Lewis River Hydroelectric Projects

FERC Project Nos. 935, 2071, 2111, 2213

2017 Annual Report

Lewis River Aquatic Fund Projects

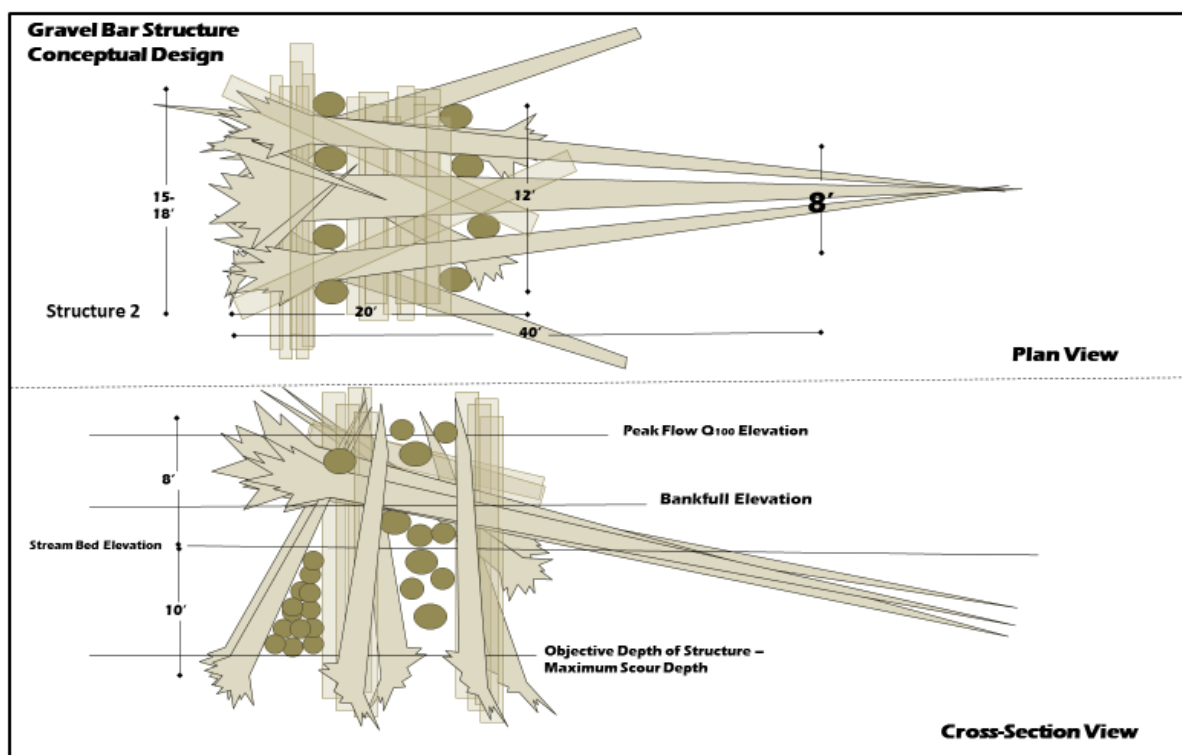
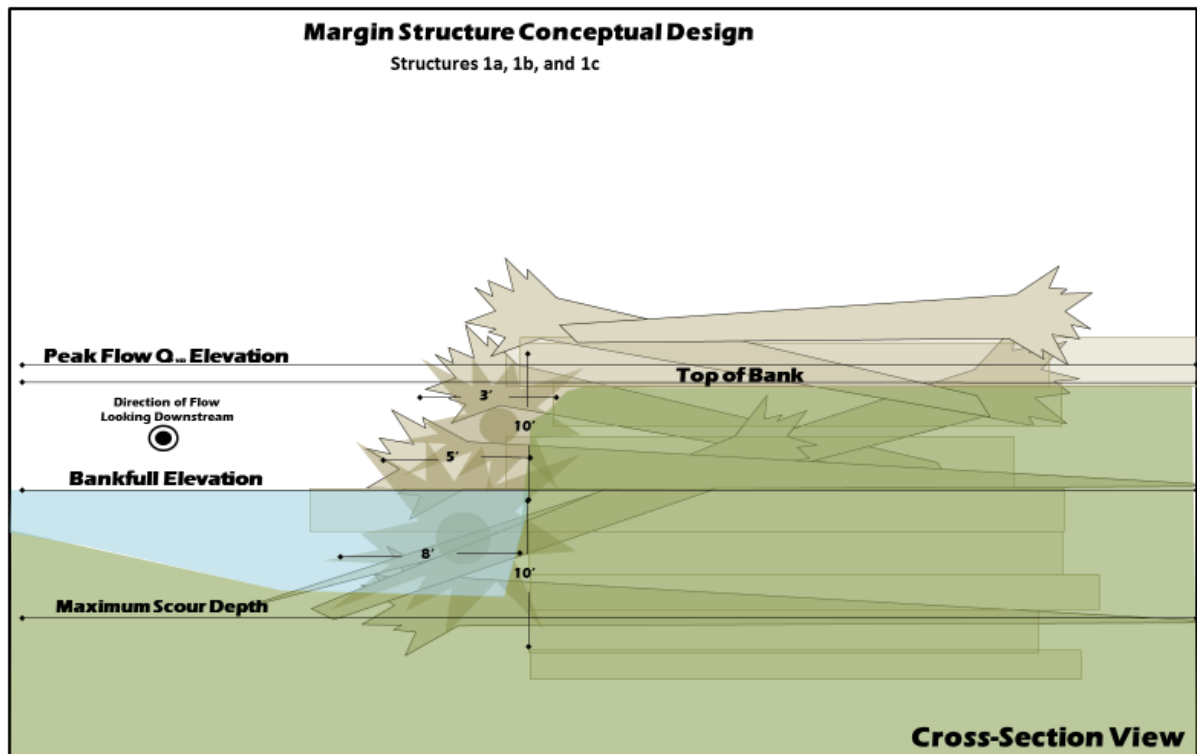
- 4. This reach is a very volatile reach; need to show how structures will function for an extended period of time (e.g. 10 years).**
-These types of structures have been used in similar rivers with great success. The structure durability assessment within the document explains methods and rational for each mode of failure.

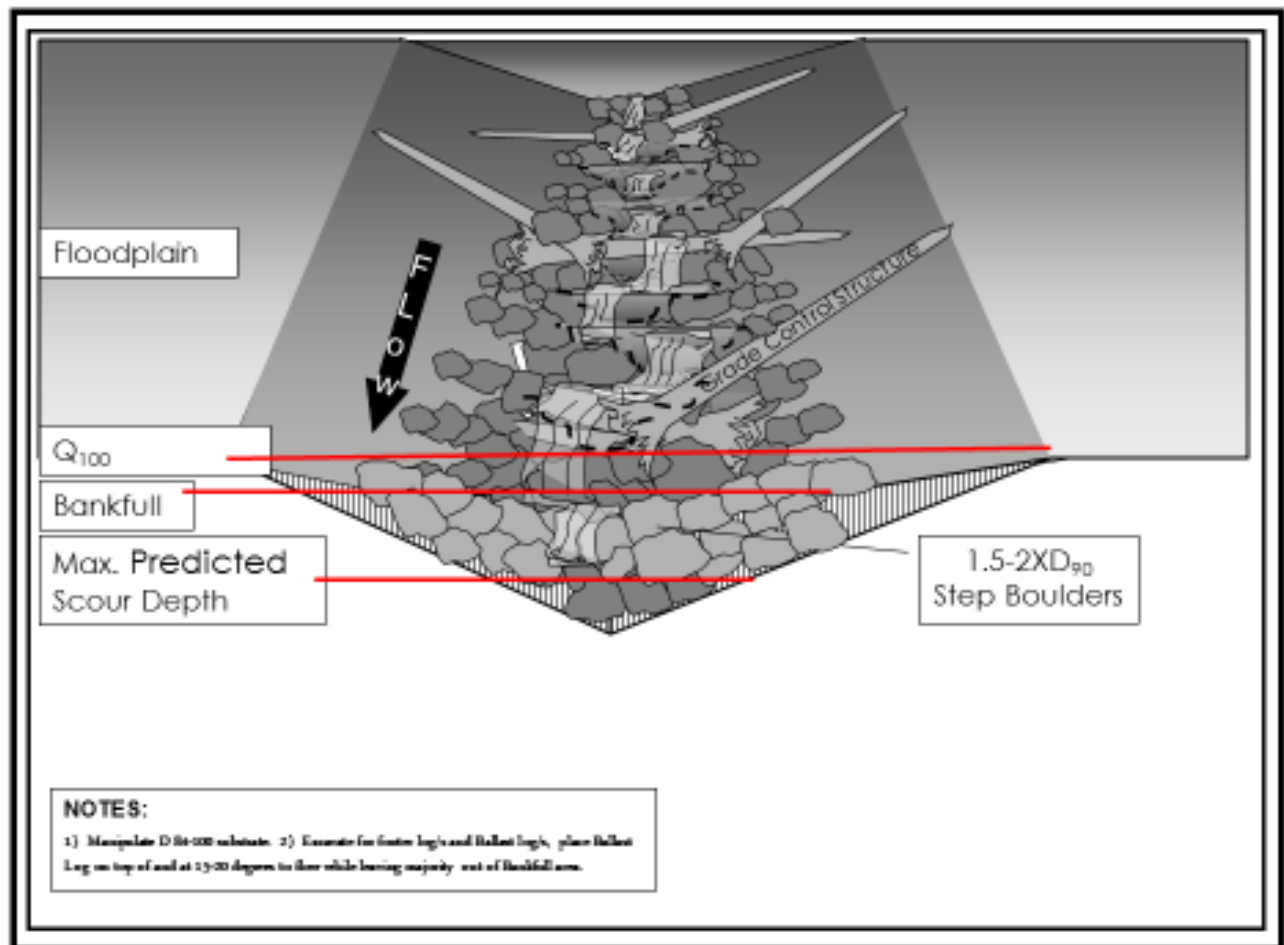
- 1. The proposed approach is not clearly articulated; the final proposal should clearly show the proposed treatment areas, describe the treatments, and explain the rationale for the approach.**

Conceptual drawing are provided in the full proposal.
